## MEMORANDUM

**To:** Harry Bronozian, MS; Chemical/Environmental Engineer  
**From:** Ann Maest, PhD; Buka Environmental  
**Date:** 11 December 2019  
**Re:** Missing elements and underestimation of risk in Lydian's 2019 NI 43-101 technical report

**Figure 1. Leachate management during closure for the Amulsar Project.** Note that BRSF runoff and pit wall and backfill leachate will be discharged to the environment without treatment during closure.

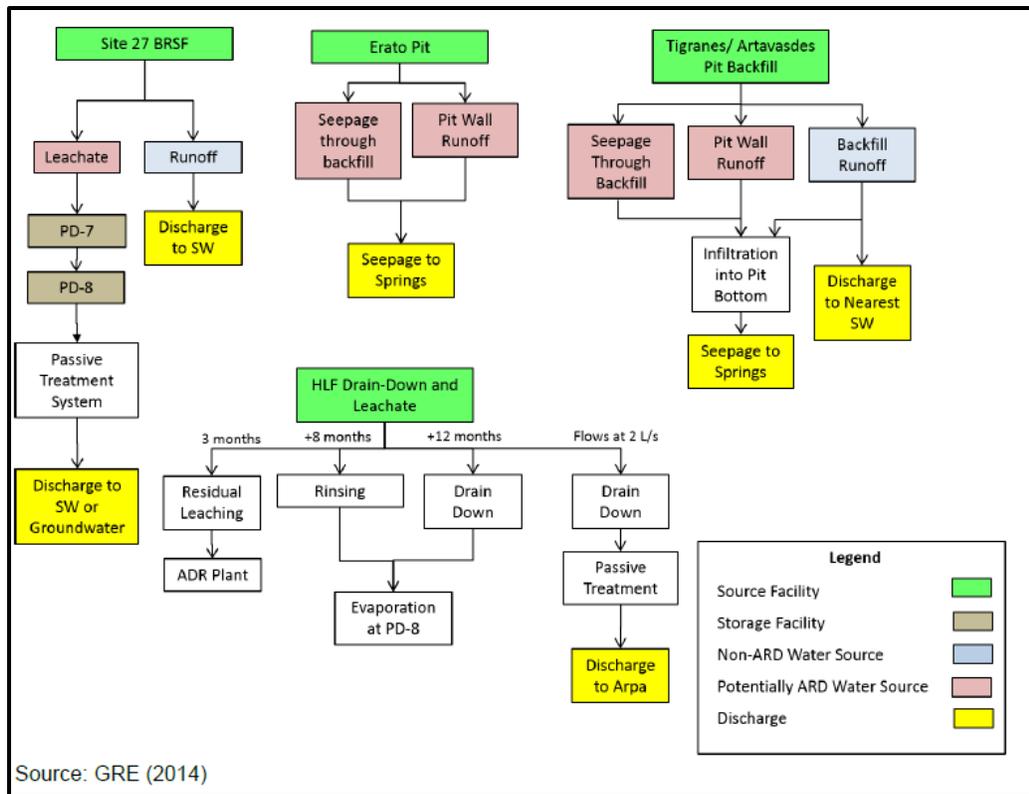
Lydian states in its response letter to the government of Armenia (Lydian Armenia, 2019) that leachate from the BRSF will not need treatment during closure because the cap system will "prevent any rainfall" from contacting waste rock – thus reclassifying BRSF runoff as non-contact water during closure. It is highly unlikely that the cap and evapotranspiration layer mentioned will be 100% effective, yet this is Lydian's assumption. Figure 26-16 in the Technical Report (reproduced as Figure 1 below) shows passive treatment of BRSF and HLF leachate during closure but no capture or treatment of runoff from these facilities. The figure also shows that leachate from Erato and Tigranes/ Artavasdes pit backfill and walls will not be treated during closure. Lydian assumes that the backfill will be 100% non-acid-generating ("NAG"; Lydian Armenia, 2019) and will not leach metals or other mine contaminants to the environment in concentrations that could create water quality risks. This assumption contradicts waste rock leach test results, is overly optimistic, and is not accounted for in contingency measures or costs.

Lydian issued a response letter to the ELARD and TRC (2019) review (Lydian Armenia, 2019). The letter states "...the Company commits not to discharge any untreated contact water from the site to the environment" (emphasis added). Lydian's definition of contact water is too limited. The Technical Report divides water at the mine into three categories: contact, impacted, and non-contact, with "impacted" water including runoff from haul roads, crushing, the conveyor, non-acid generating waste rock, and topsoil stockpiles. Runoff that contacts ore (from the crusher and conveyor) and waste rock is considered *contact* water and is normally sent to the contact water pond for monitoring and treatment. Lydian declares, without requiring monitoring, that "impacted" water will be lumped with non-contact water because "...this water is assumed to not require additional treatment<sup>8</sup> prior to release to the environment." (Lydian, 2019, p. 18-13). By creating a term and a non-standard definition, Lydian is again underestimating risks and costs for mine water treatment that will be needed at Amulsar.
